Subject: RE: NYM/2020/0392/FL Castlebeck Farm, Harwood Dale

LOCATION PLAN CONCRETING WORKS AT CASTLEBECK FARM

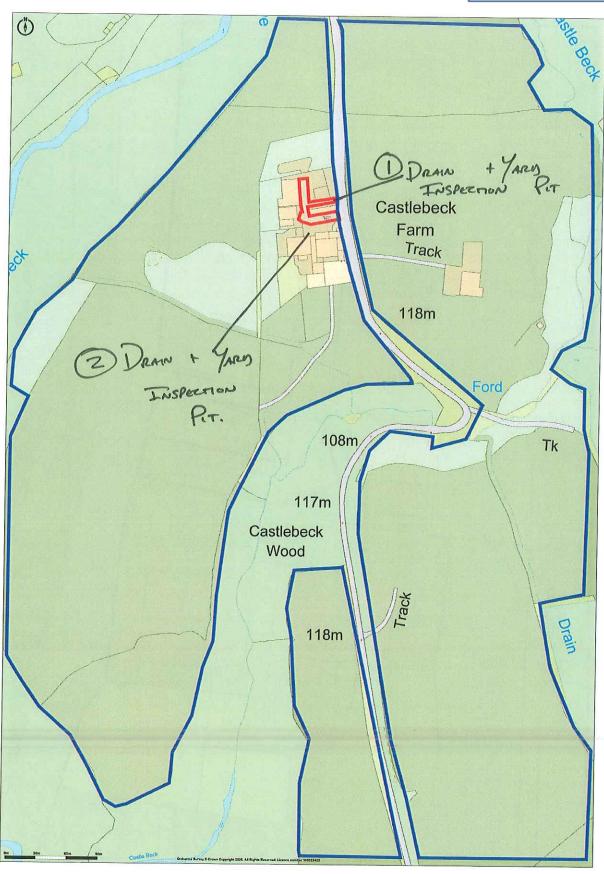
2. Sustainable Drainage System

Unfortunately the electronic mapping system which we use is currently experiencing problems, and so I have annotated the location plan which has been submitted as part of the Application to identify the position at which drain and yard inspection pits are being installed or upgraded. I refer to the drain and yard inspection pit at Point 1. This drain is being installed to catch any water which will drain towards the road. Any water is then diverted in to an underground network which will head to the west of the farmyard to be drained into an existing field drainage scheme. I refer to the drain and yard inspection pit identified as No.2. This drain will catch any of the water which drains in a southerly direction off of the concrete, and again which will connect in to an existing drainage scheme heading out in to the land to the west of the farmstead. You will see during your site inspection that the yard is

profiled in such a way that it will not run towards the road. Furthermore the concrete can be constructed in such a manner that again any water will be drained away from the road and in to the farmstead towards the drains being installed. The drains are required as part of the Grant funding process, to improve all matters relating to drainage. Taking into account the above, discharge on to the Highway will be reduced significantly.
